Peach Bottom Atomic Power Station, Unit 1  
Facility Operating License No. DPR-12  
NRC Docket No. 50-171

Subject: Supplemental Information in Support of Request for Alternative Schedule to Complete Decommissioning Beyond 60 Years of Permanent Cessation of Operations

**Supplement to Request Alternative Schedule to Complete Decommissioning  
Beyond 60 Years of Permanent Cessation of Operations**

**Peach Bottom Atomic Power Station, Unit 1  
Docket Nos. 50-171**

### **Question 06 – Limitations**

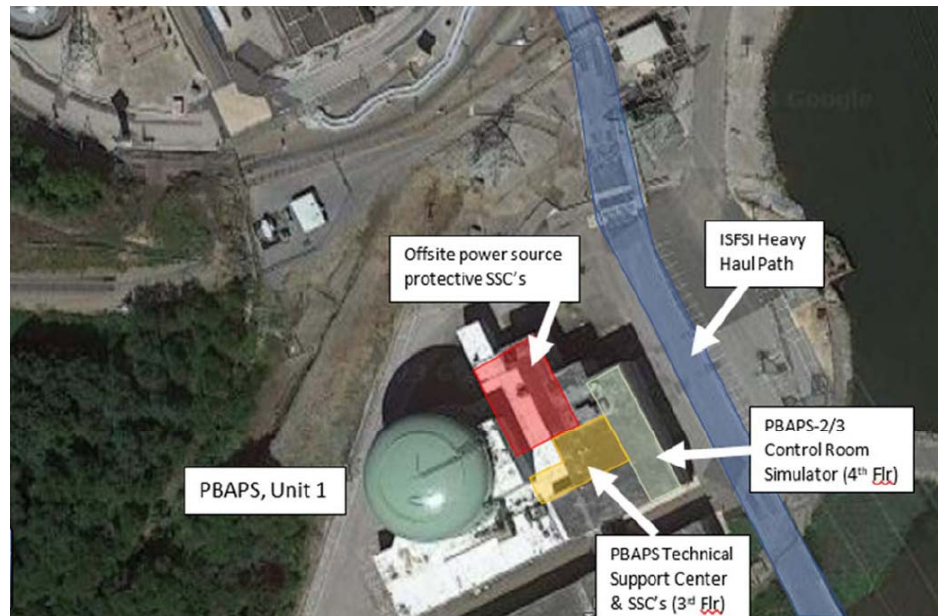
*“Limitations on available physical space due to configuration of the site and functional facilities adjacent to PBAPS [Peach Bottom], Unit 1, increase the risk of performing decommissioning activities. The facilities in the vicinity of PBAPS [Peach Bottom], Unit 1, support operation of PBAPS [Peach Bottom], Units 2 and 3, and therefore there will not be limitations following cessation of operations of the adjacent units on site.”*

*Please characterize the limitations based on common decommissioning techniques used in industry today or the ones planned to be use and the degree of increased risk from Peach Bottom Unit 1 decommissioning activities. Indicate whether this increased risk of performing decommissioning prohibit the ability to protect public health and safety.*

Both existing structures and geographic features surround PBAPS-1 which physically limit decommissioning activities as depicted in the figure below. Physical space is limited by a steep hillside which spans the southwest to north-northeast of the facility, within approximately 25-ft from the Containment Building. The site is of course bounded by the Susquehanna River on the East side. Both the east and south portions of the PBAPS-1 facility are connected to adjacent buildings and structures which support PBAPS-2 and PBAPS-3 operations, emergency response facilities and ISFSI Heavy Haul Path (HHP).

The preliminary plan for decommissioning PBAPS-1 considers utilizing common methods and techniques from the decommissioning industry. The approach is anticipated to include a new suitably sized and located opening in the containment building necessary for dismantlement/disposal of large components, due to limitations (i.e., size/orientation/elevation) associated with original PBAPS-1 containment access pathways. Additionally, it would be expected that adjacent to containment, a confinement structure would be erected outside and immediately adjacent to containment and the new opening to maintain the necessary radiological controls, including monitoring and engineered features for segmentation, packaging, and transportation preparation activities, as applicable. Concerns unique to PBAPS-1 for the handling and disposal of the graphite components from the core of this HTGR type reactor are detailed in response to Question 08.
